TECHNICAL SERVICE BULLETIN

Technical Service Bulletin: 10C-0844

ROCKWOOD & FLAGSTAFF FIFTH-WHEEL – NAUTILUS CONVENIENCE CENTER REMEDY INSTRUCTIONS

ROCKWOOD & FLAGSTAFF FIFTH-WHEEL – NAUTILUS CONVENIENCE CENTER REMEDY INSTRUCTIONS

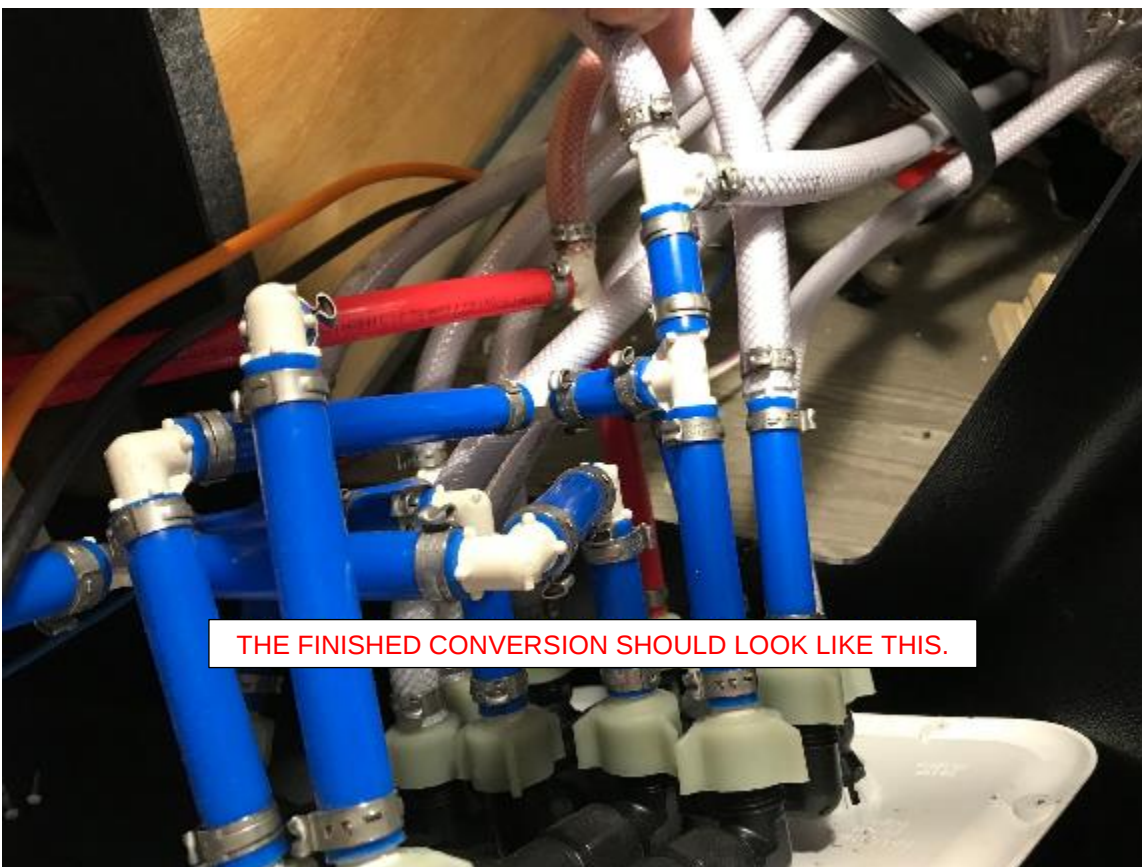
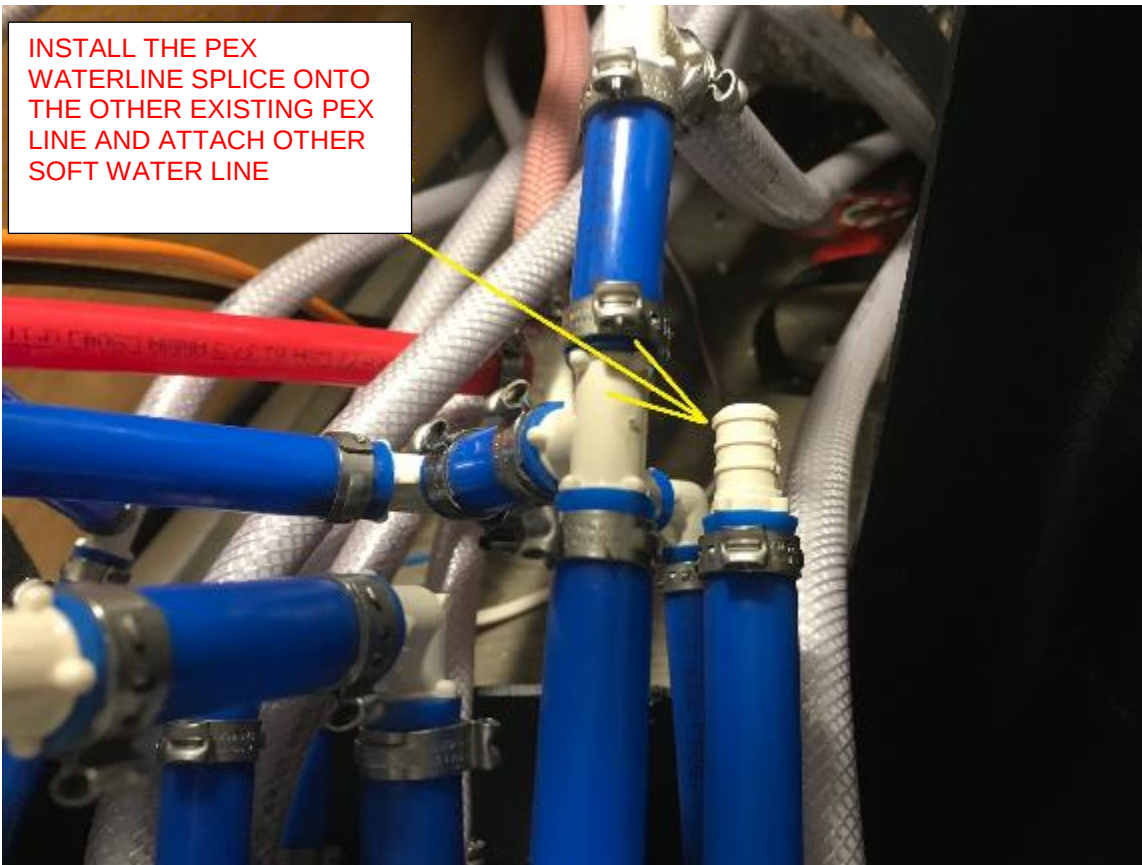
INSTALL THE PEX
WATERLINE SPLICE ONTO
THE OTHER EXISTING PEX
LINE AND ATTACH OTHER
SOFT WATER LINE
